Access Compliance Report Public Rights-of-Way (Pedestrian Signals)

Intersection ID: N/A	Main Street:	Cross Street: N/A	Location: N/A
ADA ID: 27BA058F182E	Signal Type: One Push Button-Non APS	Overall Compliance: No	Severity Score: BTN 1: N/A BTN 2: N/A No BTN: N/A
Codes/Mitigation Info/Possible Solution		Field Measurements/Component Compliance

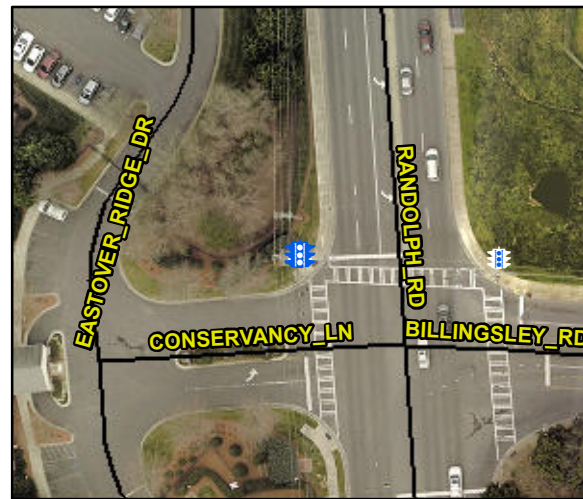
PROW/ADA: R404.2, R404.3, R406.2

Possible Solutions: Provide Push Button Extension. Remove and Replace Clear Space.
